**Skookumchuck Wind Energy Project Proposed Habitat
Conservation Plan and Incidental Take Permit for
Marbled Murrelet, Bald Eagle, and Golden Eagle
Lewis and Thurston Counties, Washington**

Final Environmental Impact Statement

Title of Proposed Action: Skookumchuck Wind Energy Project Proposed Habitat Conservation Plan and Incidental Take Permit for Marbled Murrelet, Bald Eagle, and Golden Eagle.

Figure 2.1-1. Project Area and Facilities

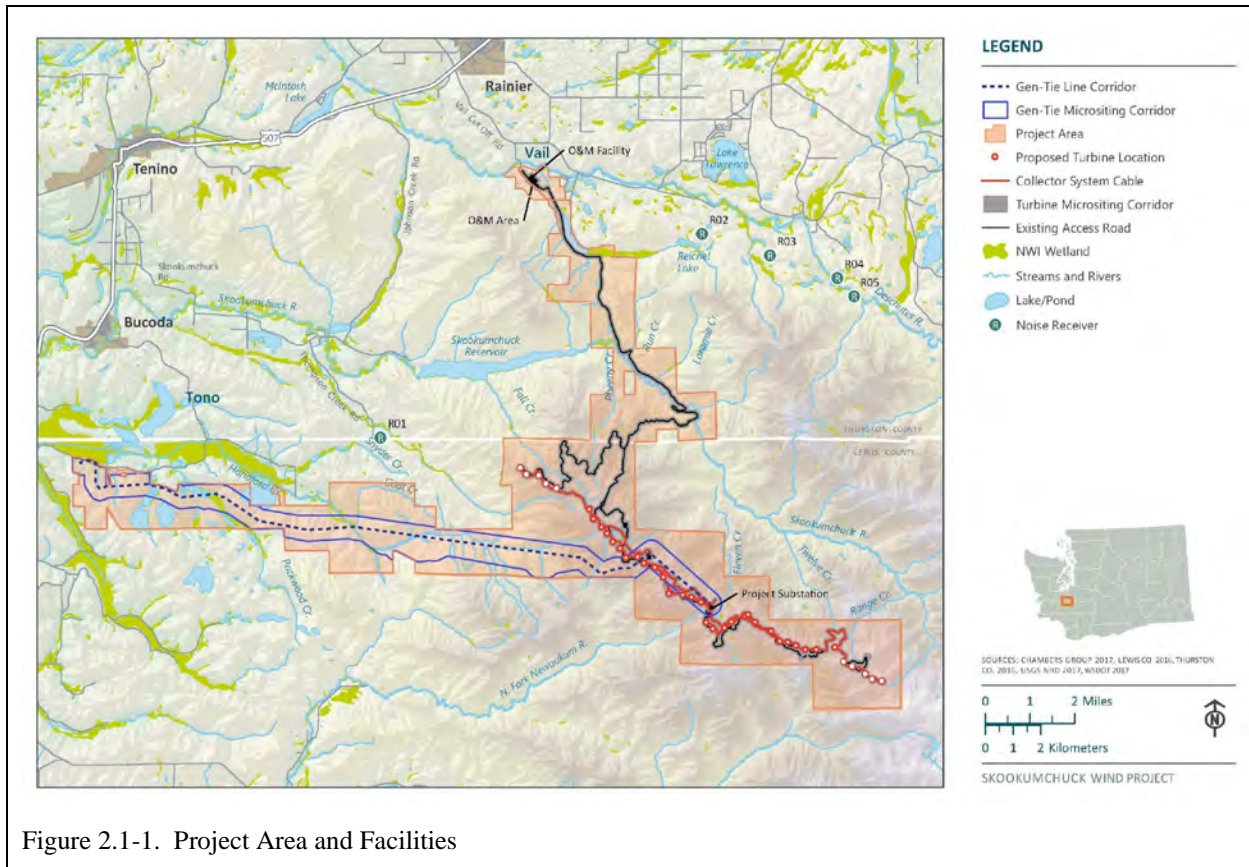
- The extent to which riparian areas may be impacted by the project is not currently clear. Figure 2.1-1 would seem to indicate that a significant portion of Hanaford Creek could fall within the powerline right-of-way and that a significant portion of Skookumchuck Creek runs parallel to the service road. Due to vegetation removal and management, both the road and the powerline, including its electrical collection system, could significantly affect stream shading. We recommend that the FEIS further define the extent to which water bodies may be impacted by the project, including the nature of the potential impacts, and the specific discharges and pollutants likely to impact those waters.

Figure 5.1-1. Project Wind Turbine Generator Locations (Project HCP; Chambers Group and WEST 2019)

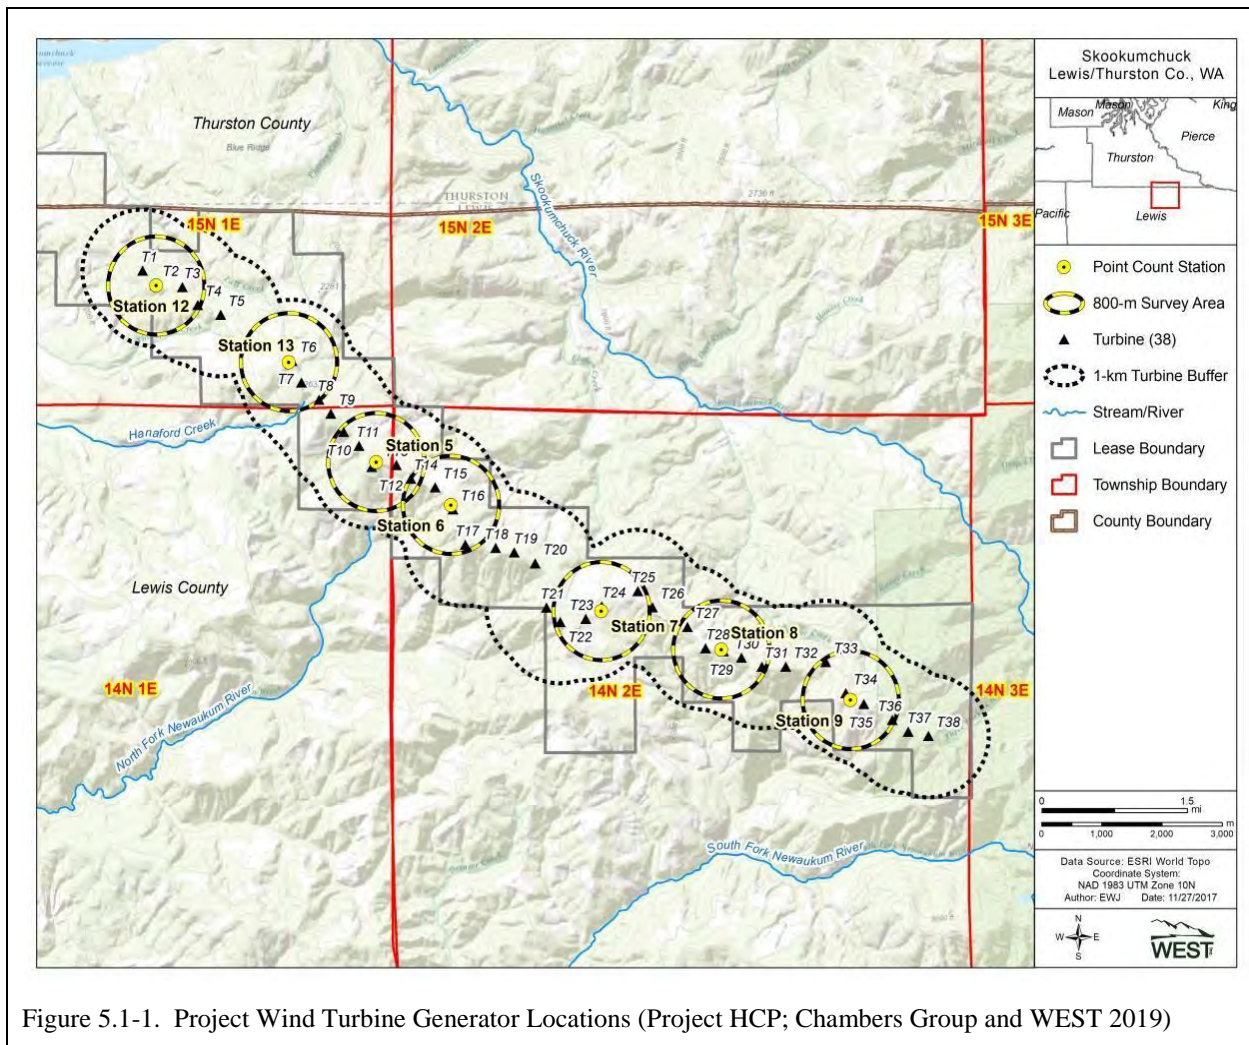
- AGY-2-1 • Figure 5.1-1 does not appear to illustrate the proposed powerline corridor or the underground collection system. We recommend that Figure 5.1-1 be updated to include this information.

- As stated in the section above, if the analysis of the road alignment demonstrates that there are sensitive resources⁸ within the proposed corridor, we recommend that alternative alignments be considered within the FEIS. We recommend that these alternative alignments be incorporated as a component of the alternatives.
- Figure 5.1-1 does not appear to illustrate the proposed access routes. We recommend Figure 5.1-1 be updated to include this information.

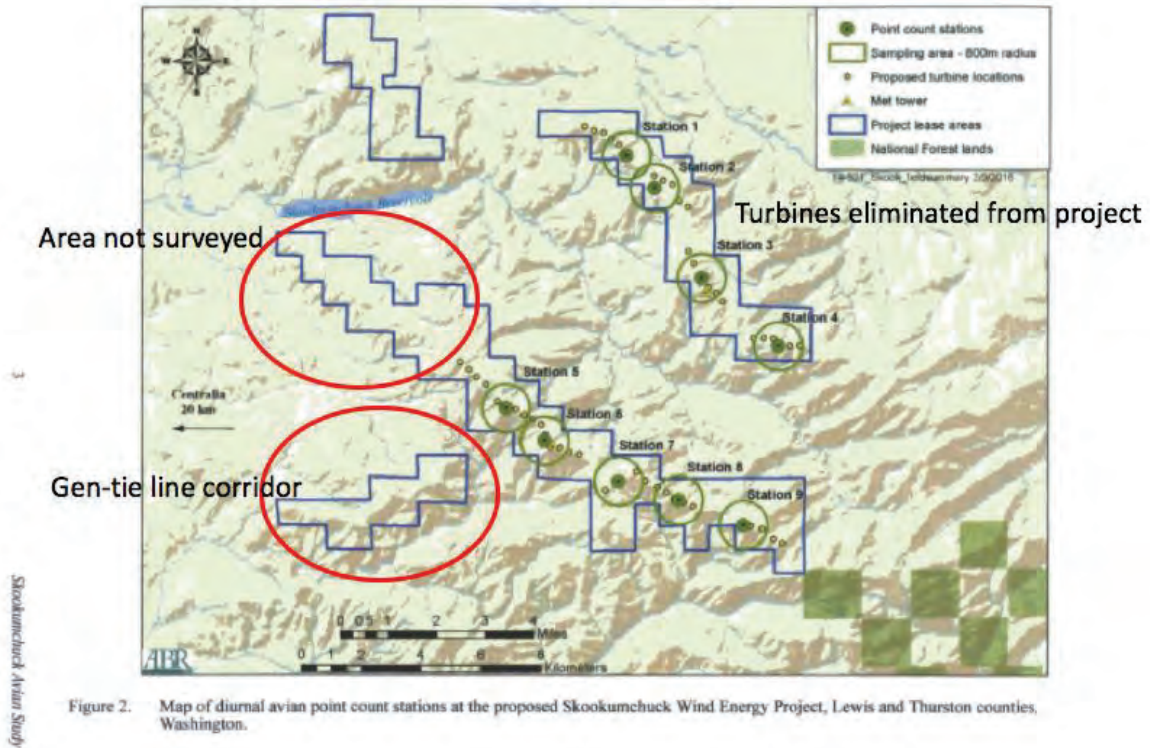
- ORG-2-5** | To better document the potential avian collision risk at the Project site, the HCP and Final EIS should include additional avian studies in the unsurveyed northwest end of the WTG line as well as along the 17-mile gen-tie corridor. The avian activity study conducted at the project site (HCP Appendix B) detected 68 bird species in the vicinity of nine survey stations; four of these survey stations were located in the proposed northern line of turbines subsequently eliminated from the project; five survey stations were located in the proposed southern line of turbines but only in the southeast end of this line (see map below from HCP Appendix B, Figure 2 with circles and labels added for clarity).

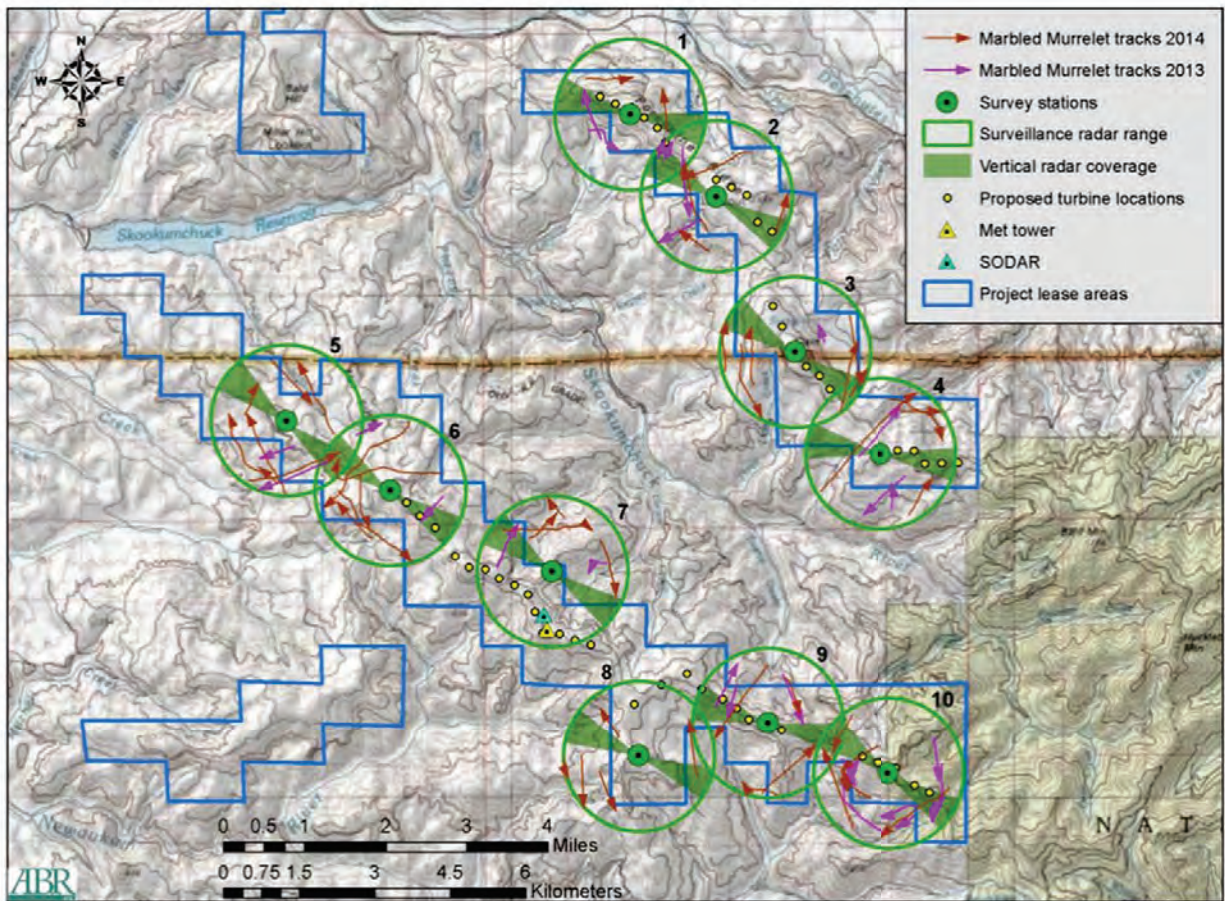
The proposed project is on a ridge, and according to the DHCP, murrelets fly within rotor height. The rotor swept area (RSA) of the proposed turbines is 25-135m; and 8 of 21 murrelet targets flew below 135m, thus within height of the blades (p. 15 in Attachment A of the DHCP). The DHCP conducted a collision-risk analysis using high avoidance rates (90-99%), which are based on no murrelet-specific studies (p. 20 of Attachment A in the DHCP). The DHCP should consider more recent studies to better approximate avoidance rates (e.g., see Kelsey et al 2018¹¹ for vulnerability scores).
